AC-26-12

SP-2026-00066 (Appeal)
SIGN-2025-00305 (Building Safety – Sign Permit)

MEMO

Subject: AC-26-12, SIGN-2025-00305: Lindmark Companies ("Applicant") appeals the Planning staff's decision to DENY a sign permit for a billboard conversion to a digital billboard for the property located at 4441 Osuna Rd NE, zoned NR-LM.

FORMETCO	
2963 Pleasant Hill Rd. Duluth, GA 30096-3808	
20mm 144 x 448 DBB UNISTRUT MTG	
9'-5" x 29'-3" 20mm F-TILE++ DBB	
SIZE B	SCALE 1:45
DWG NO. B-2614	SH 1 OF
REV. -

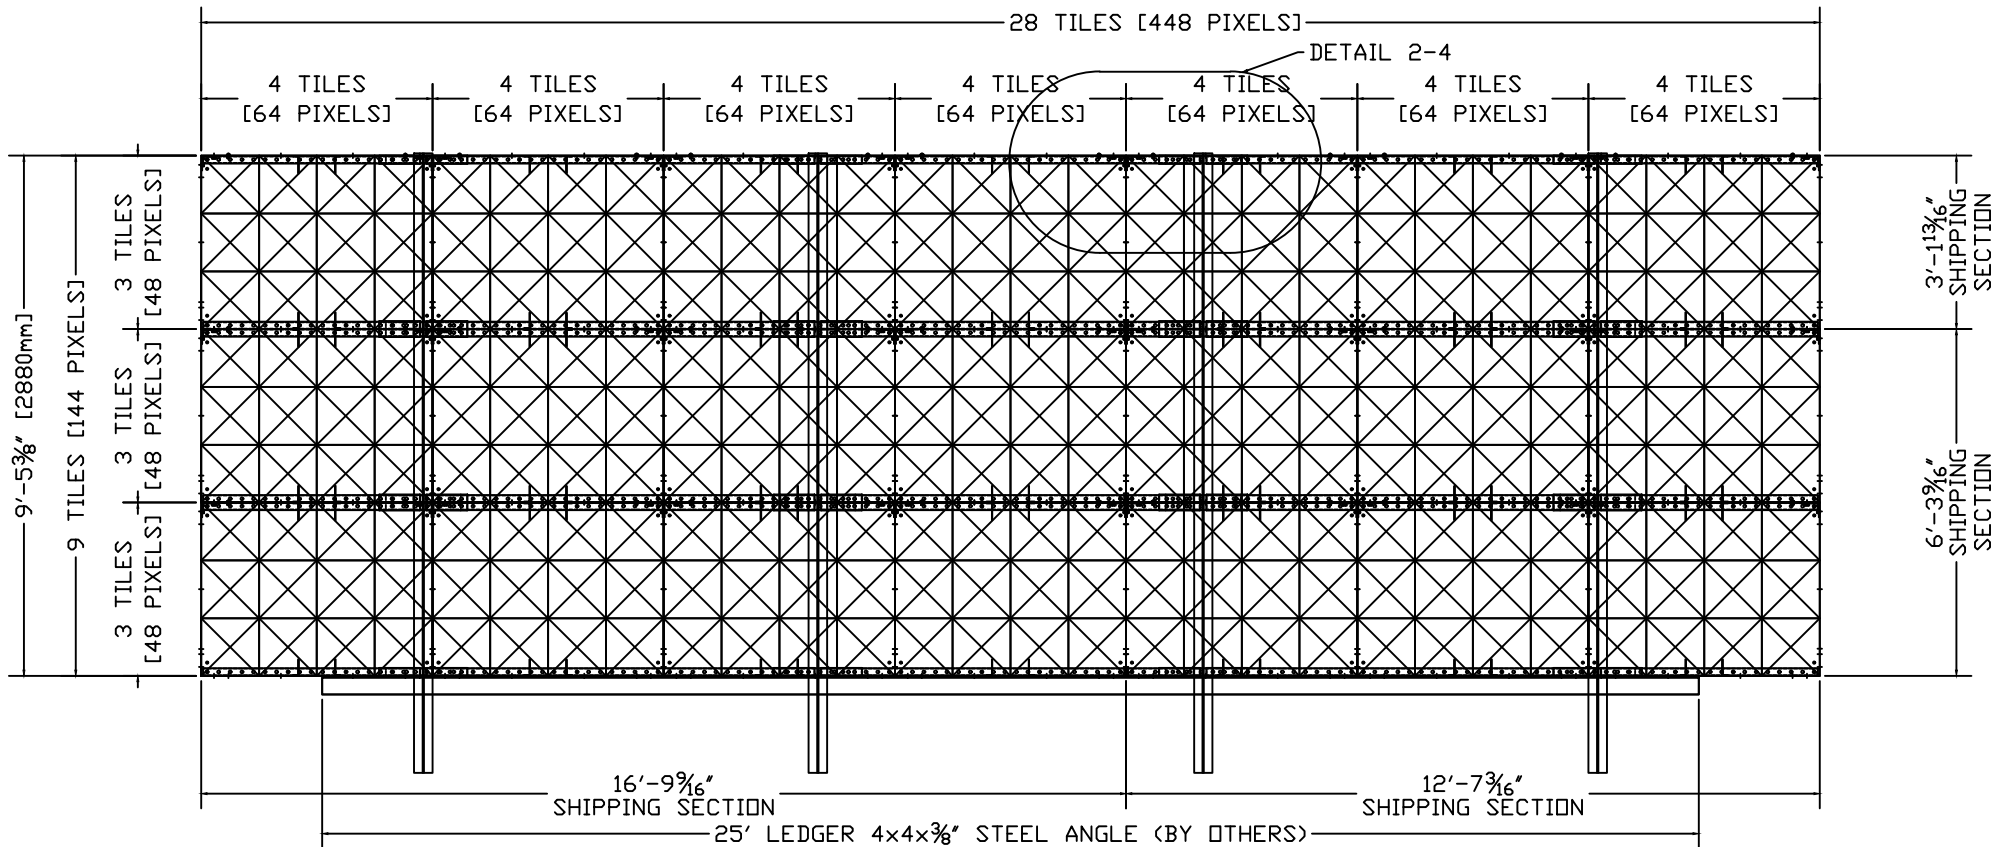
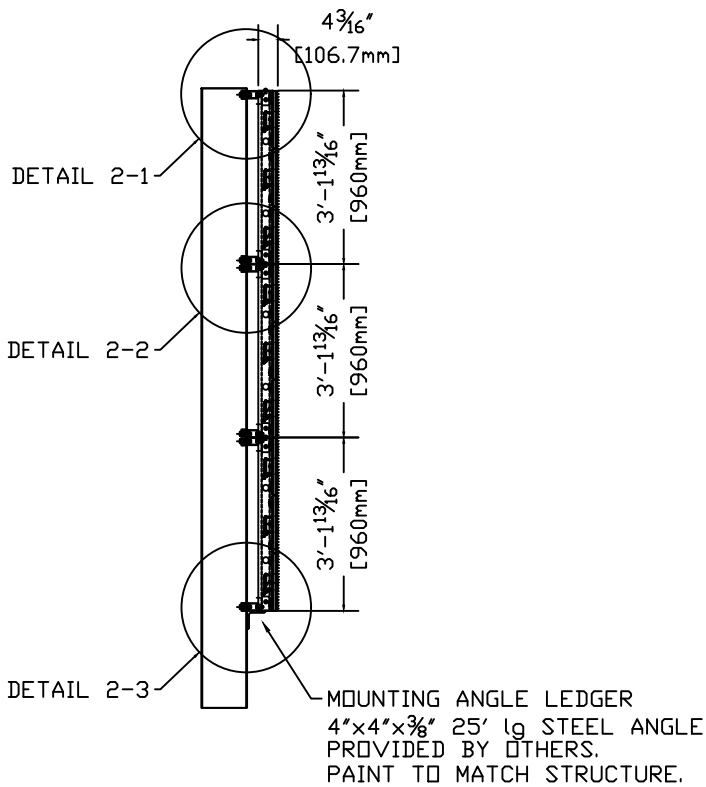
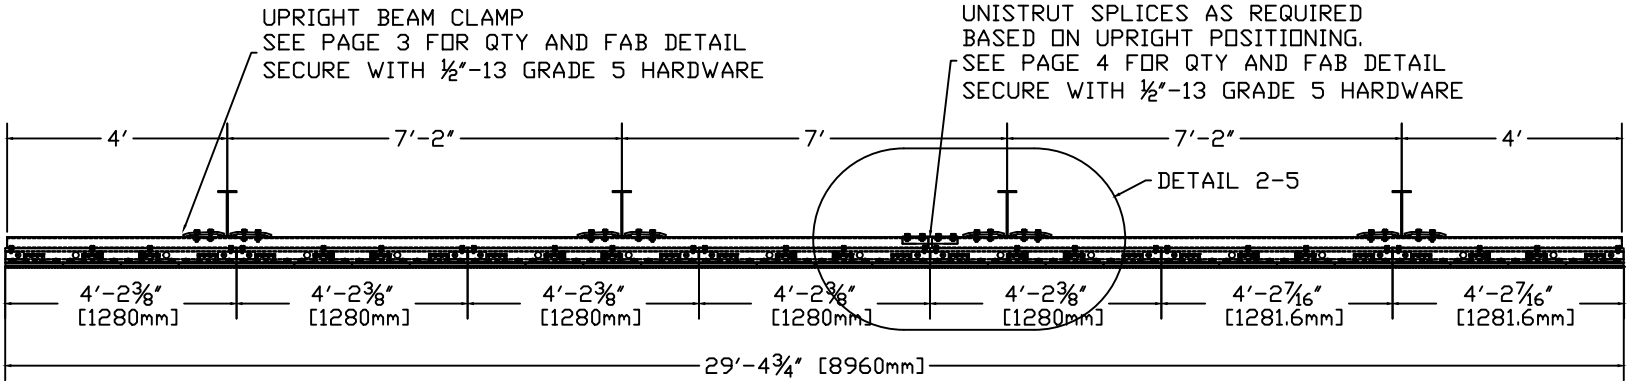
Provide structural engineering for ground sign, pole sign, or sign structure (2021 NMCBC H105.1).

FORMETCO		2963 Pleasant Hill Rd. Duluth, GA 30096-3808	
20mm FTX 144 x 448 - 1Ø		ELECTRICAL POWER RISER	
SIZE B	SCALE nts	DWG NO. B-2615	SH 2 OF REV. -

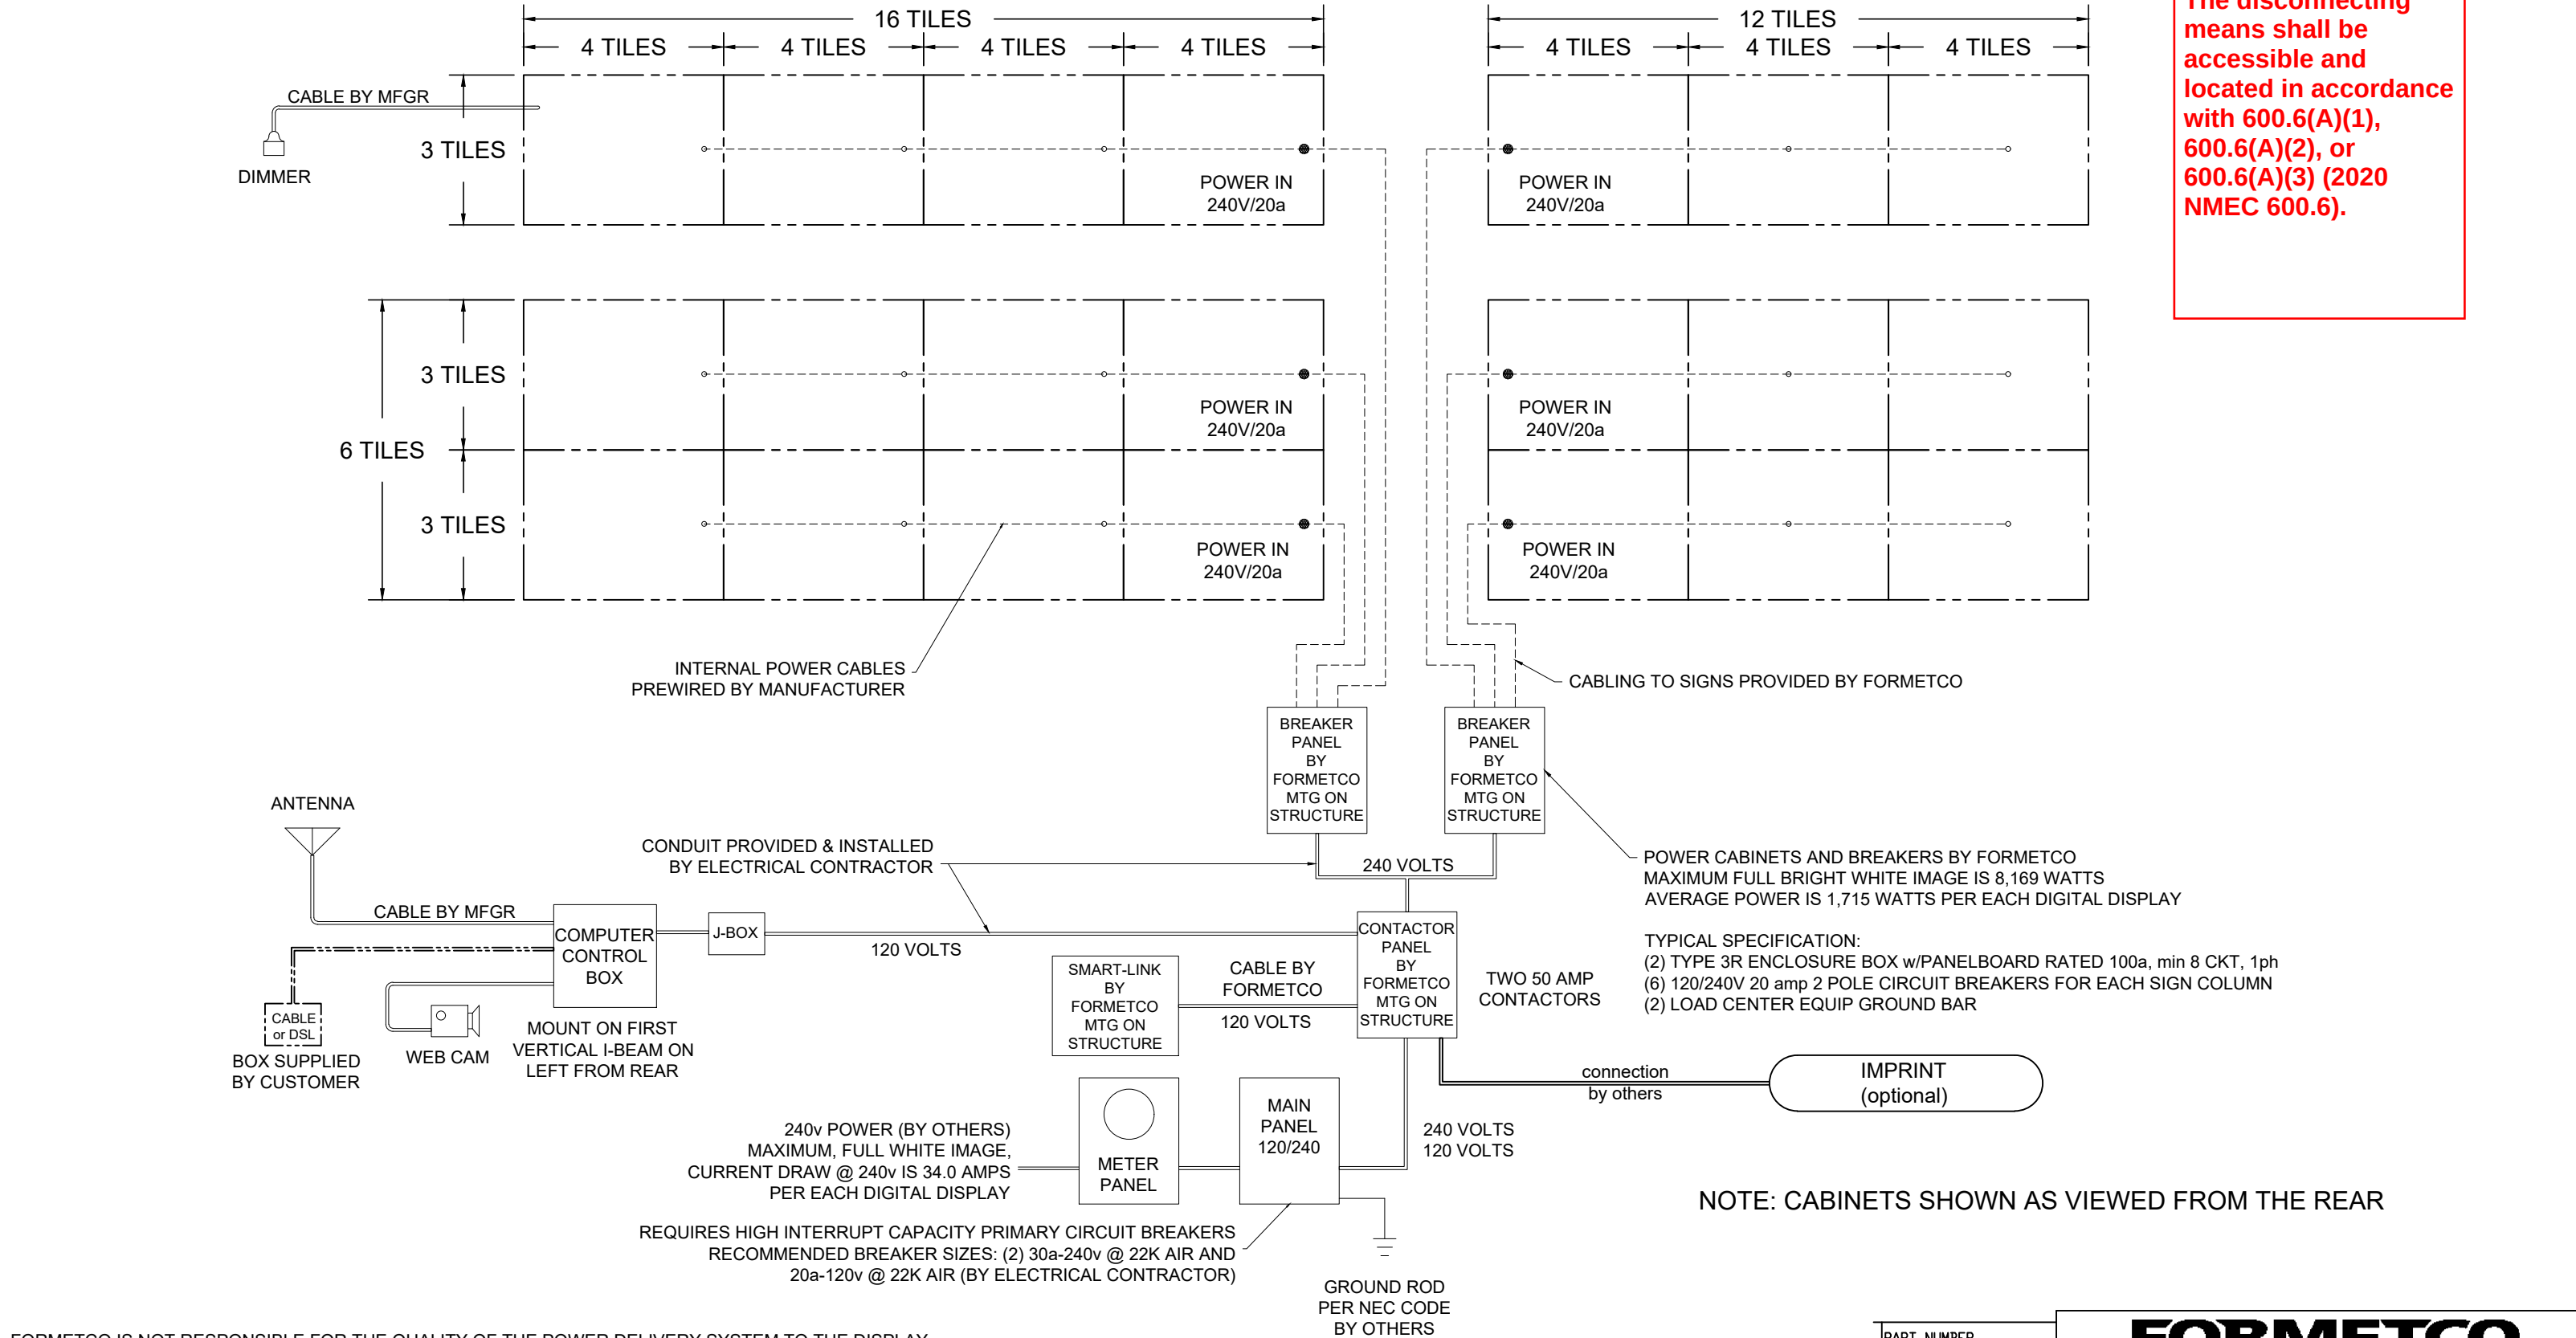
The disconnecting
means shall be
accessible and
located in accordance
with 600.6(A)(1),
600.6(A)(2), or
600.6(A)(3) (2020
NMEC 600.6).
